Access Compliance Report

Public Rights-of-Way

(Curb Ramps)

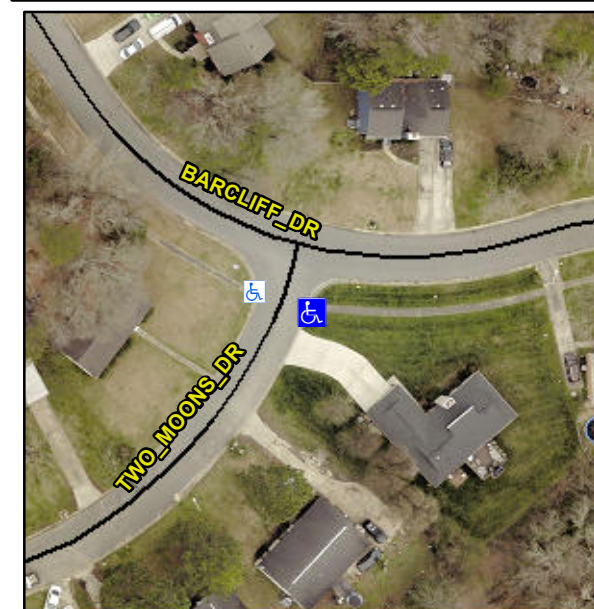
Intersection ID: 14177	Main Street: BARCLIFF_DR	Cross Street: TWO_MOONS_DR	Location: SE
ADA ID: E18CE7E8DED6	Ramp Type: Directional1	Initial Pass/Fail: Fail	Overall Compliance: No
Severity Score: 12.5			
Codes/Mitigation Info/Possible Solution		Field Measurements/Component Compliance

R304.2.2

Remove & Replace Entire Ramp.
